DS-K1T673 Series MinMoe Terminal
Release Notes (2024-03-26)

DS-K1T673TDGX,DS-K1T673TDWX,
DS-K1T673TDX, DS-K1T673DX
DS-K1T673DWX

Naming Rule:
D for Desfire, Felica and M1 card
W for Wi-Fi, F for fingerprint
G for SIM card,
B for Bluetooth, QR for QR code
WE for 868 MHz ,WB for 433 MHz | Firmware Version | ARM:
ACS_673_F1plus_EN_STD_V4.10.0_build240326
ACS_673_F1plus_EN_NEU_V4.10.0_build240326 |

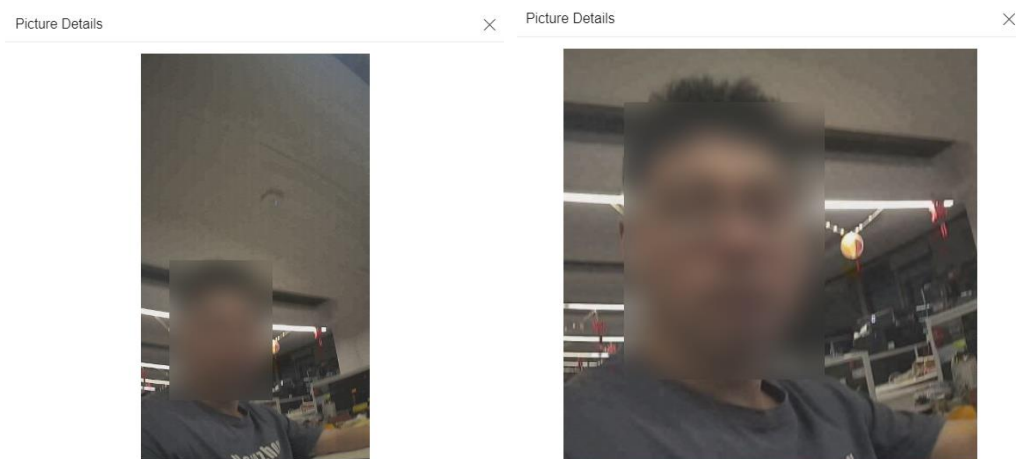
5. Support captured face picture matting
   Default captured picture & face picture matting:
